Re: Rapiscan AIT System Radiation Survey Reporting

FORM R-0646-1
(Single Pose)

**R-0646-1 Addendum
(Documentation Errors)**

1. In Beam Dose Measurement: Survey Table. 1

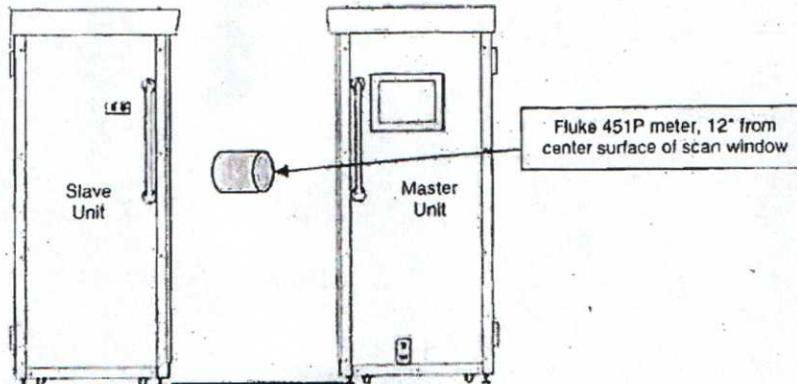
1. No value indicated for background radiation. Typical values range from 7uRem/hr to 13uRem/hr at sea level. Note: Absence of value has no adverse impact on calculations.
2. Technician indicated scan time as 7 seconds. Correct scan time is 3 seconds.
3. TABLE 1: Incorrect presentation of data in Column 3 for Measured Exposure. Indicated values are 33uR and 40uR. Corrected values are 3.3uR and 4.0uR. The values were corrected by technician when calculating Effective Dose.
4. TABLE 3: Incorrect presentation of data in Column 6 for Dose Equivalent. Indicated value is .18 uRem. The correct value should be 1.8 uRem.

The service technician should attend refresher training.

The corrected data indicates this system was operating within expected parameters. No re-survey is required for this system.
